CITY OF WEST DES MOINES
CITY COUNCIL MEETING COMMUNICATION

ITEM: Mill Ridge Plat 1, North of the intersection of Harper Lane and S 92nd Street – Plat property into 31single family lots, four (4) outlots and four (4) street lots – Mill Ridge Homes LLC.– FP-003206-2016

RESOLUTION: Acceptance of Public Improvements and Approval and Release of Final Plat

ATTACHMENT B

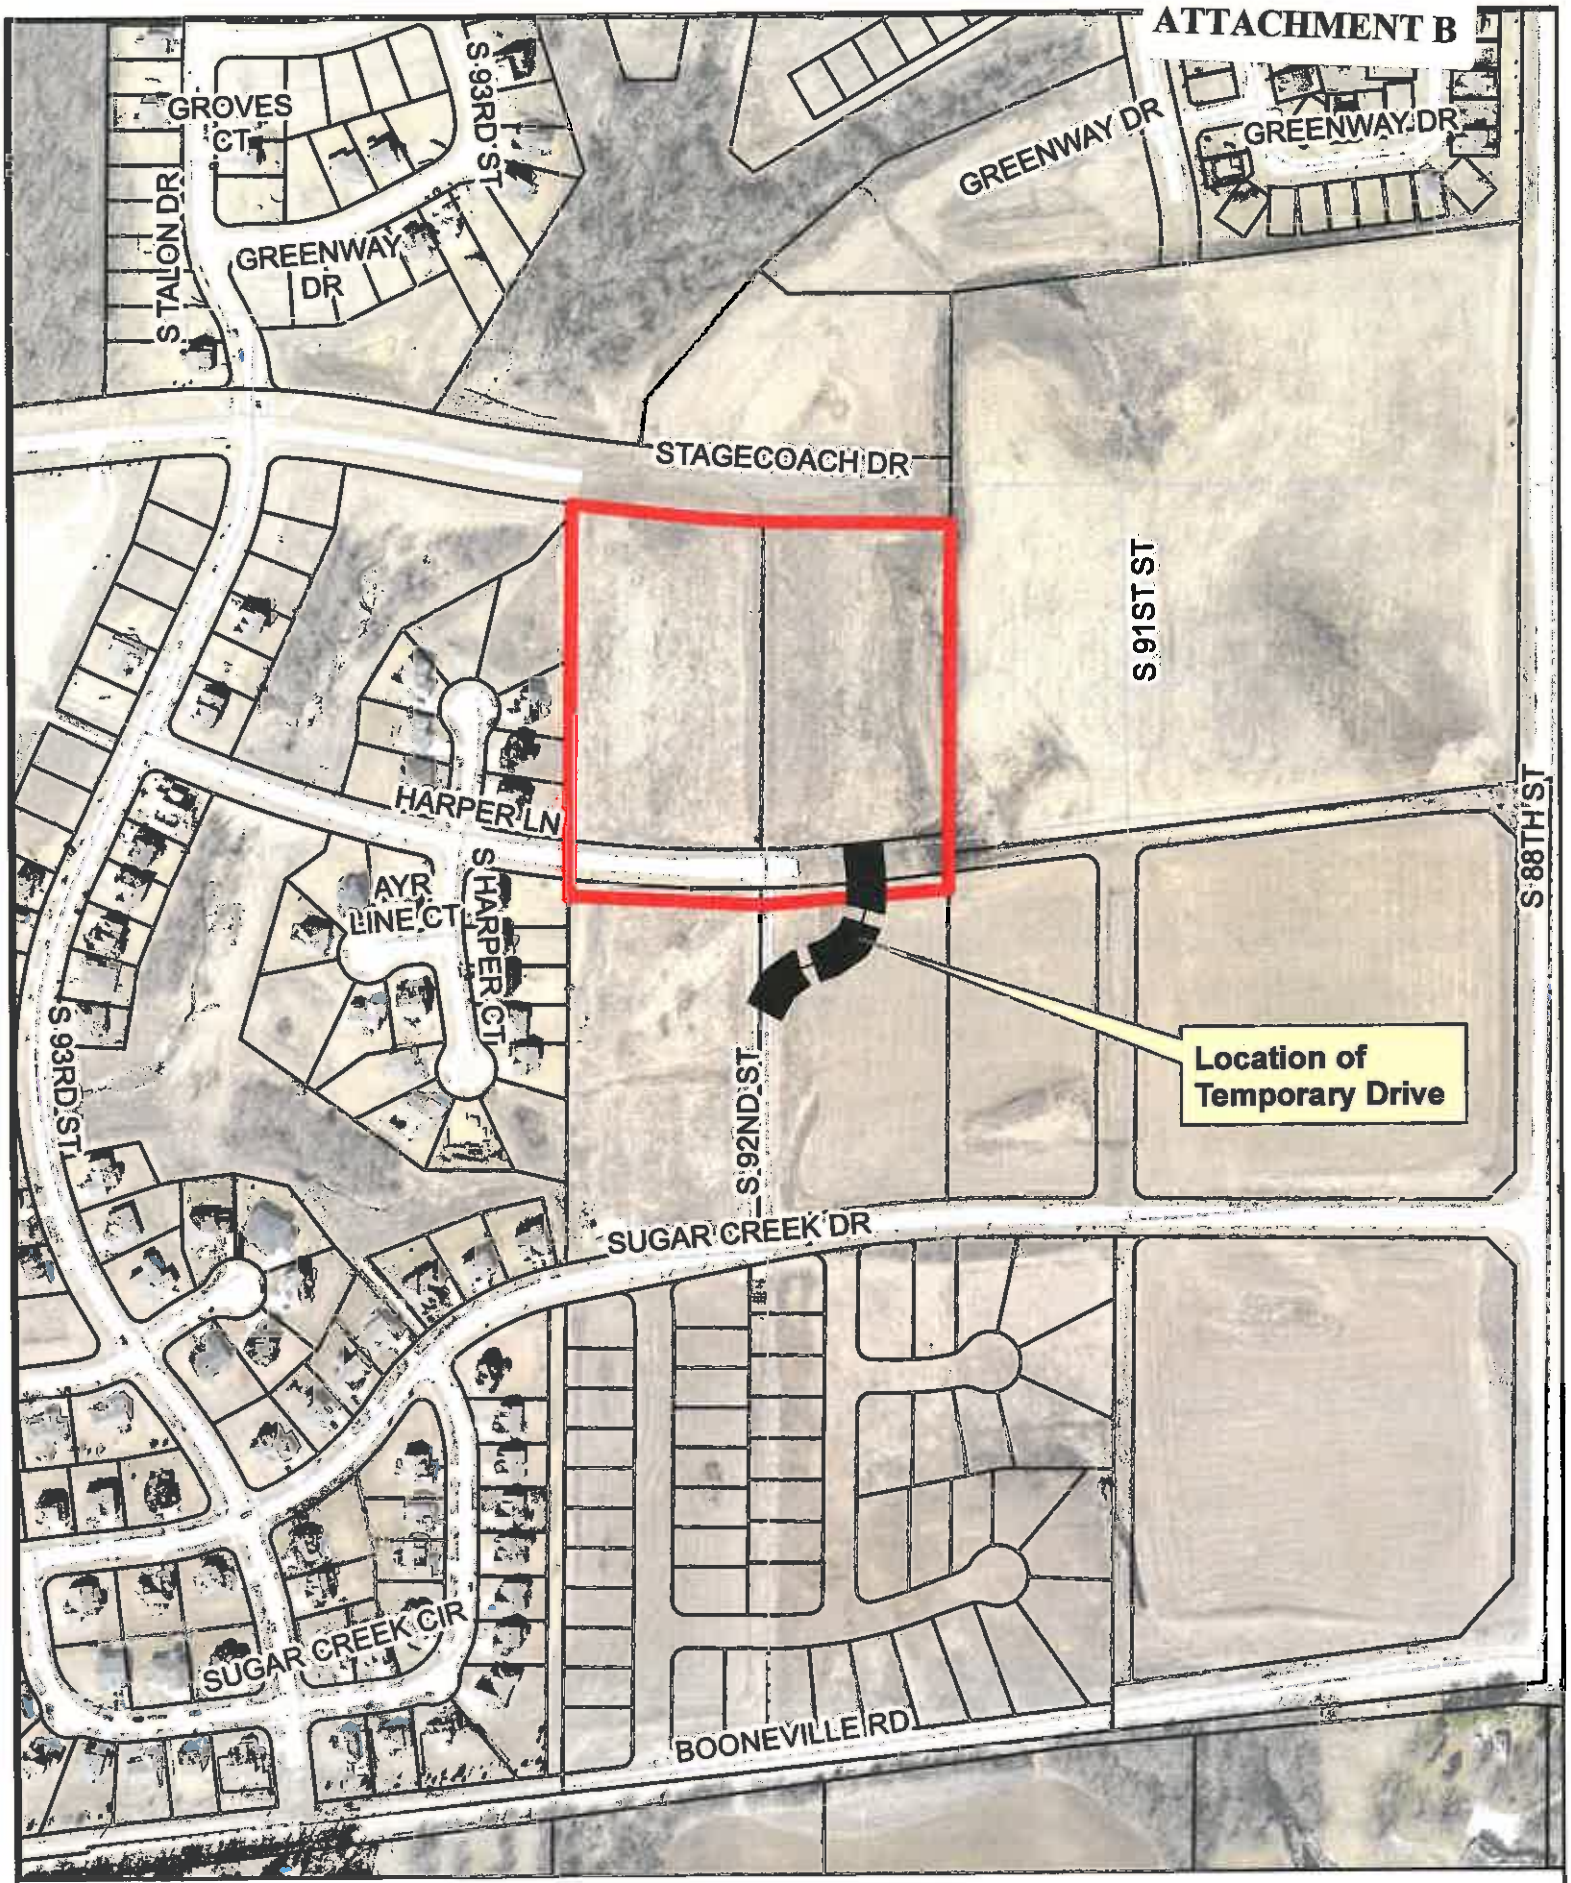
- *Temporary Second Access:* Due to the delay in the construction of Stagecoach, this development will lack the two points of access needed under the fire code for approximately 6 months (all access will come from Harper Lane). The applicant is proposing a temporary solution in which they would construct a gravel drive connecting proposed Radley Street to the existing S. 92nd Street that connects to Sugar Creek Drive. S. 92nd Street was vacated by prior Council action but has not yet been removed. Staff is comfortable with the proposal, but recommends a condition of approval that the temporary gravel connection be for only a 6 month period of time, constructed so that it support 75,000lb GVW and be maintained at all times, including snow removal. If the temporary connection is needed longer than 6 months, it is recommended that the drive be paved.

4. The temporary access drive between the proposed Radley Street and existing S 92nd Street be allowed to be gravel for a maximum of a 6 month period of time, constructed so that it supports 75,000lb GVW and be maintained at all times, including snow removal. Should the temporary drive be required longer than 6 months, the drive shall be paved.

ATTACHMENT D

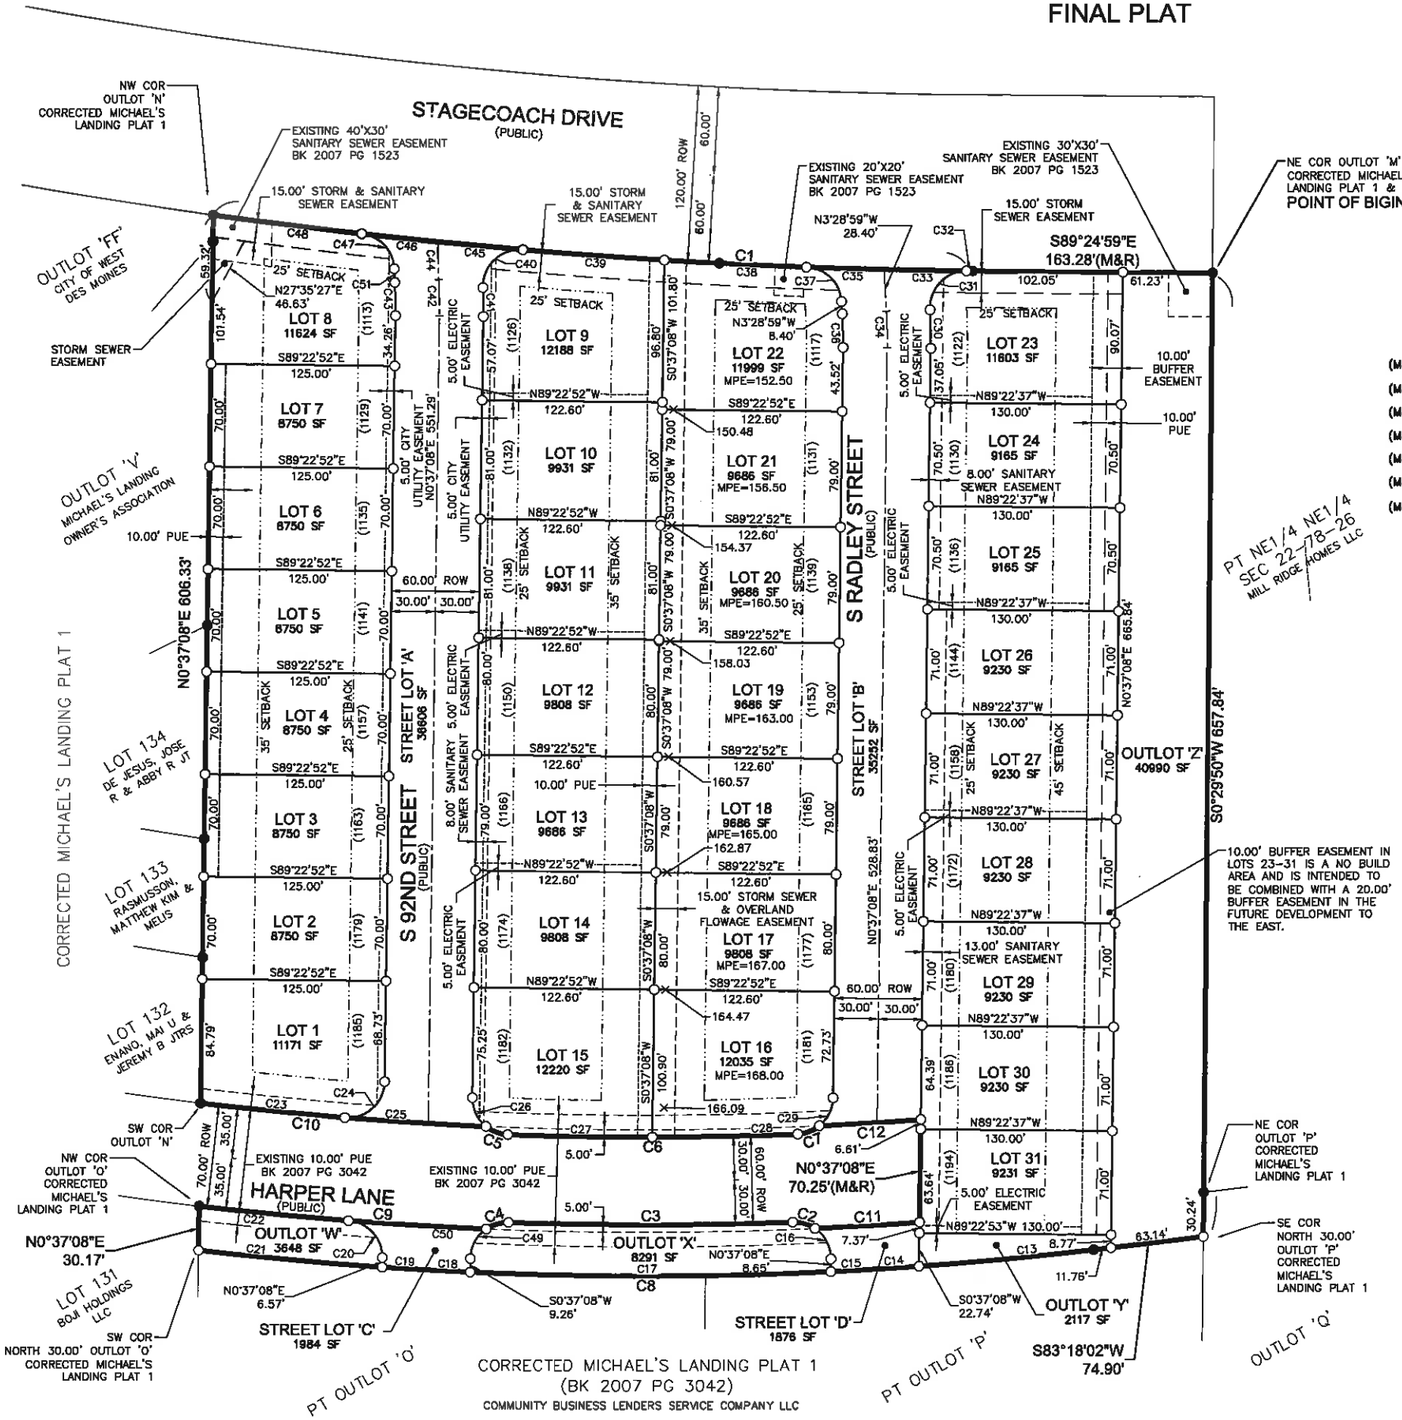
- *Public Utility Easements*: The final plat identifies a public utility easements (PUE) in the front yard of lots 1-15 which front onto S. 92nd Street. Title 10, Chapter 3, Section 2, Subsection C(1) of the City Code requires that PUE's be located in the rear or side yards. Originally, S. 92nd Street was designated as a Minor Collector with a 70 foot right-of-way. While amending the comprehensive plan and zoning for the area (ZC-002831-2015 & CPA-002830-2015), S. 92nd Street was reclassified to a Local Street which requires only a 60 foot right-of-way. The caveat for the reclassification was that 5 foot utility easements are platted on both sides of the street to allow for certain utilities to continue south along the originally planned path. To accommodate this, allowance of the PUE's in the front yard is the only option. City Staff has reviewed this request and supports granting a waiver of the code requirement.

2. The City Council granting the applicant a waiver from City Code to allow five foot (5') Public Utility Easements to be located in the front yards adjacent to S. 92nd Street of lots 1-15.
